King County
Department of Natural Resources
Director's Office
King Street Center
201 S. Jackson St., Suite 700
Seattle, WA 98104 - 3855

February 22, 2001

ENCLOSURE 1

OVERVIEW OF REVIEW SCOPE AND LIMITATIONS

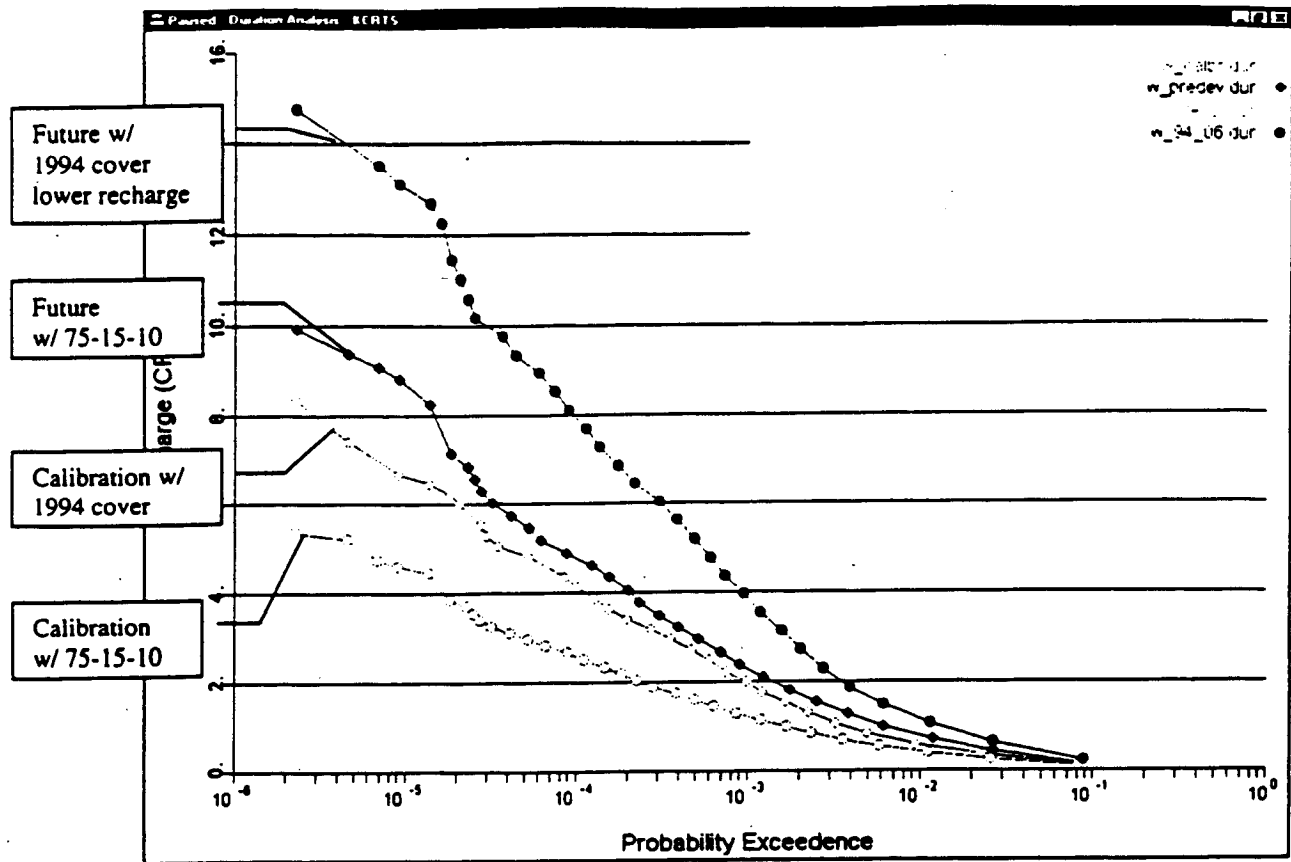
The below graphic is useful in illustrating the problem. The curve with hollow diamonds represents the runoff from the 1994 subbasin with 1994 landcover (source: HSPF calibration input file). The curve with hollow circles represents the runoff from the 1994 subbasin with 75-15-10 landcover. The curve with the solid diamonds represents the runoff used as the target flow conditions for SDW2 (source: HSPF Pre-Project input file). The curve with solid circles represents the runoff from the future subbasins with 1994 landcover.

- Existing 1994 landcover (hollow diamonds) produces lower flows than the Pre-Project landcover (solid diamonds). This is not consistent with the application of the 75-15-10 landcover assumptions.
- If the 75-15-10 landcover assumptions were applied to the existing subbasin, the resulting flows (hollow circles) would be considerably lower than those used in SMP.
- Approximating 1994 landcover applied to the future subbasin produces higher flow durations (solid circles), but may produce an easier to achieve low flow condition due to lower "existing condition" recharge from increased impervious and decreased outwash soils. Although the indication is that this was done (applied 1994 landcover to 2006 subbasins), there are no HSPF input files provided which show exactly what was done.

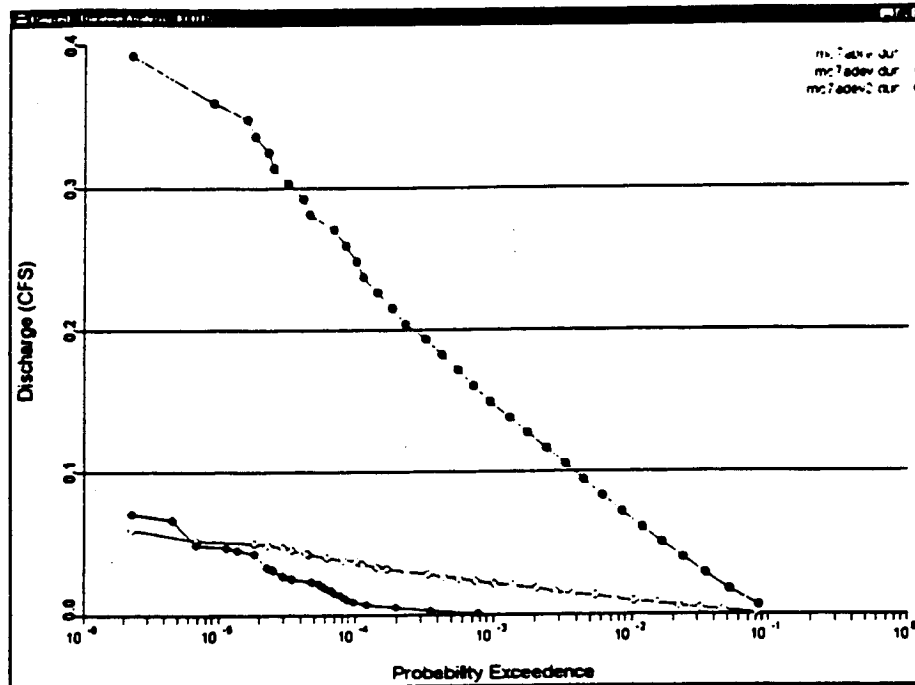
1. The modeled postdeveloped landcover assumptions are not consistent with the plan sheet entitled Proposed Impermeable Surface Area which shows 1.3 acres of total impervious coverage. When modeled, the postdeveloped flow durations are less than predeveloped flows over a majority of the flow range (compare the two curves with diamond shaped symbols. Note: solid symbol is post developed runoff without flow control).
2. No provision for the offsite flows which are being directed through the flow control pond. These flows may exceed the threshold requiring the offsite flows to bypass the flow control pond.

3. From the grading plan it appears that the pond side-slopes are steeper than 3:1, which would require fencing per KCSWDM. The proposed fencing does not extend around the proposed pond.
4. From the below graph it is apparent how significant the difference in post-developed landcover assumptions are (compare the two curves with solid symbols).
